Islandmore Wind Farm

Annex 14.1: Road Safety Audit

**Wind Farm Application, Toobrackan,
Ballaghaderreen, Co. Roscommon
Stage 1 Road Safety Audit**

Client:	Galetech Energy Services
Document No:	262305-ORS-XX-XX-RP-TR-13g-001 - RSA

Problem No. 10: Risk of HGV Queuing on Local Road to Closed Site Access Gate

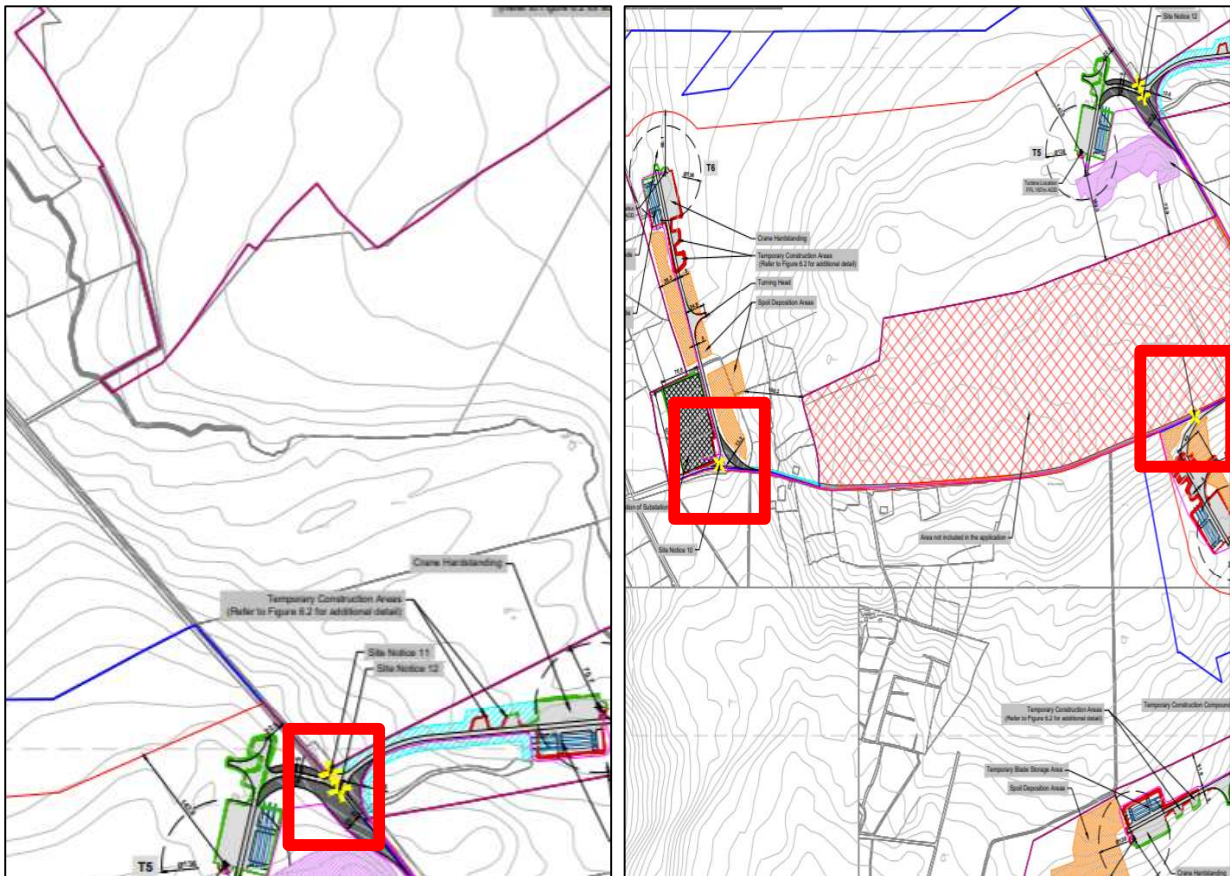
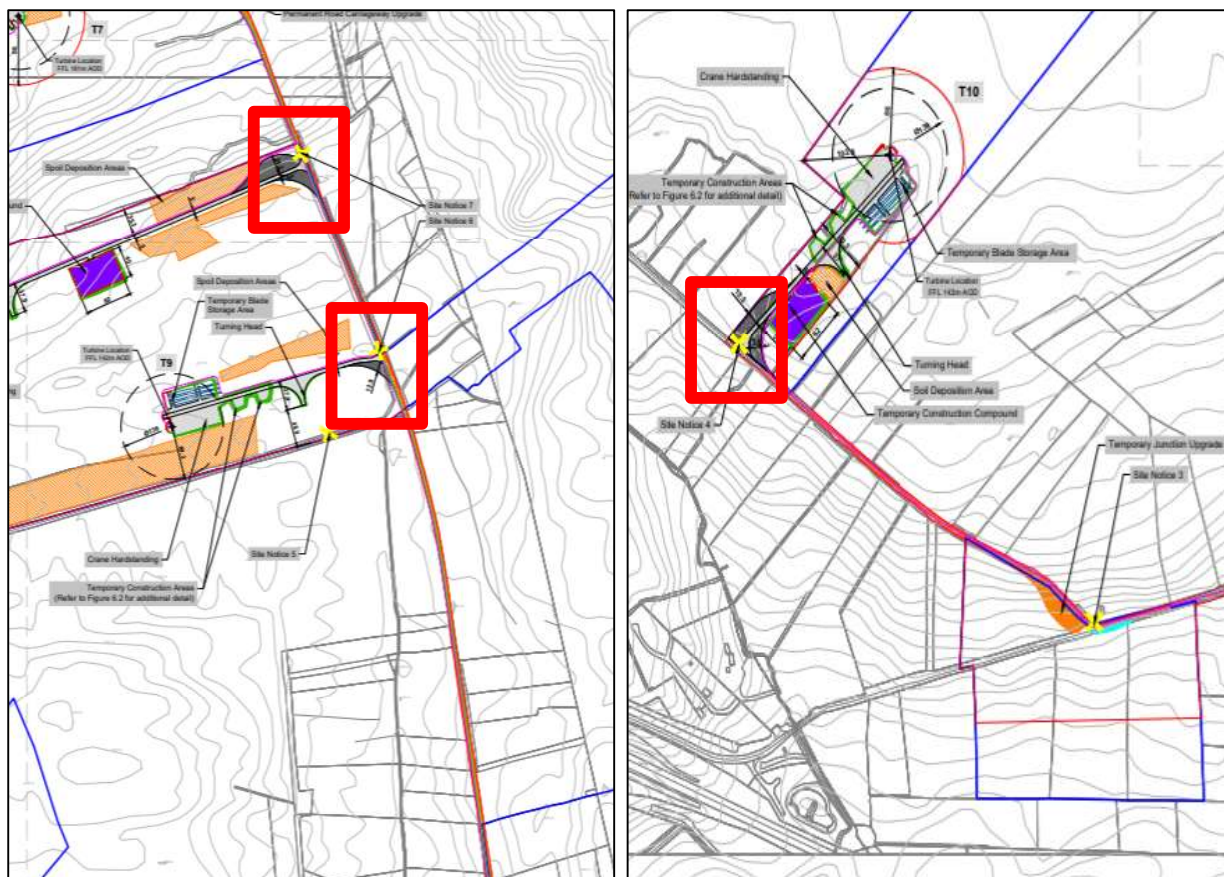
The audit team notes from the design drawings that there is a lack of clarity regarding vehicle queuing on the Local Road when the site access gate is closed. This presents a potential road safety risk, particularly for Heavy Goods Vehicles (HGVs) waiting to enter the site. Stationary vehicles on the live carriageway can obstruct traffic flow, reduce available sight distance, and create collision hazards for approaching vehicles — especially during low visibility conditions such as at night or in adverse weather. This situation increases the likelihood of rear-end or side-swipe incidents.

The design team should ensure that the site access is located to provide an appropriate off carriageway holding space for vehicles waiting to enter the site.

P10	Yes	Yes. As part of the post-consent detailed design process, the precise siting of boundary fencing and gates shall be defined. However, the design process shall ensure that gates are adequately set back from the road edge to allow a HGV pull fully off the road and to avoid queuing on the public road.		
P11	Yes	The design of a scheme of advance warning signage shall be carried out as part of		Yes
